**Subject:** RE: Storm drain back up images

**From:** Collette, Anja  
**Sent:** Tuesday, December 5, 2023 9:11 AM  
**To:** 'Jeffrey Gray'; Planning-WWW  
**Subject:** RE: Maine Woods Pre-Development Conditions

**From:** Jeffrey Gray <jgray5456@gmail.com>  
**Sent:** Monday, December 4, 2023 8:08 PM  
**To:** Planning-WWW <planning@bangormaine.gov>  
**Subject:** Maine Woods Pre-Development Conditions

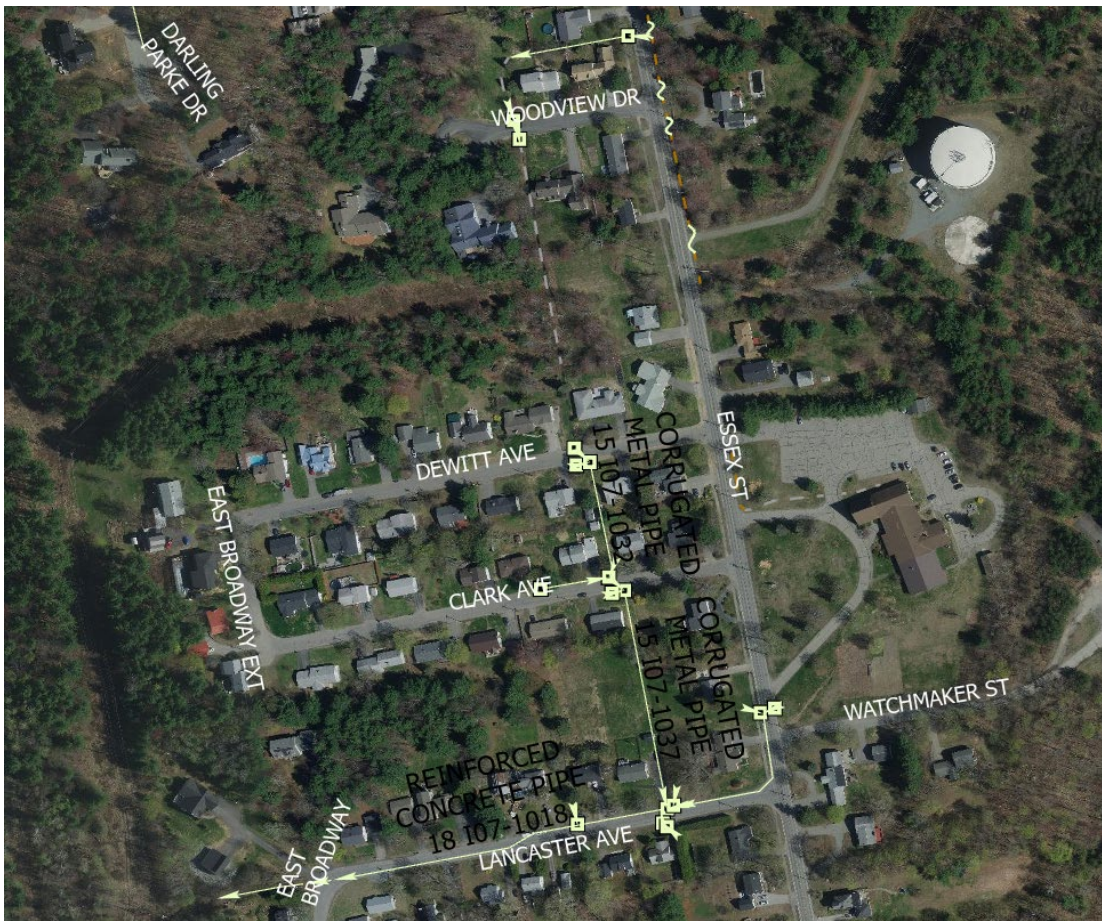
Are you requesting an additional catch basin at the corner of Essex and Lancaster on your side of the street? Your driveway has always been the low point, which makes it an ideal place to have a catch basin. Given the grades and distance to Essex Street, an additional basin does not seem warranted.

The map below shows some additional drainage from Essex and Woodview that enter the storm drain on Dewitt.

We believe the pre-development conditions that existed prior to construction are adequate.

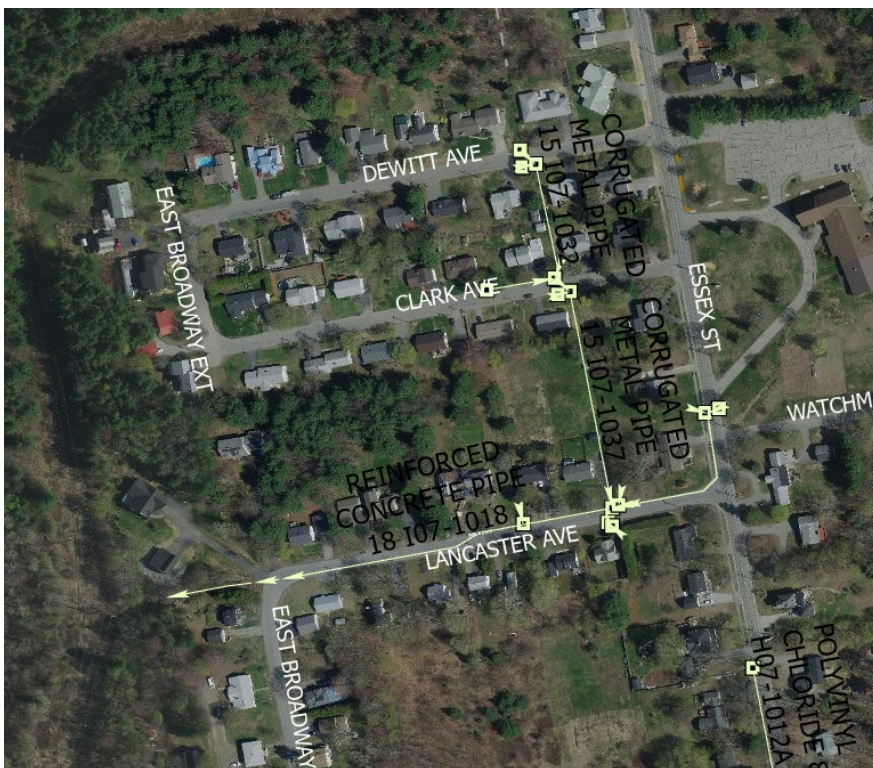
Thank you for sharing these pictures. It can be difficult to get out and inspect storm drains during rain events. I will make an effort to visit this area to see the drains working during a rainstorm. The images you shared show the storm drains working in a very typical fashion, and I would not consider

these to be problem areas based on these photos. It appears that any standing water that is present during a storm drains after the rain stops.

We maintain city-wide GIS maps to track and maintain our infrastructure. A snapshot of the city drainage system in your area is shown below. The arrows on the line represent flow direction. Our catch basins are inspected regularly, and cleaned as needed.
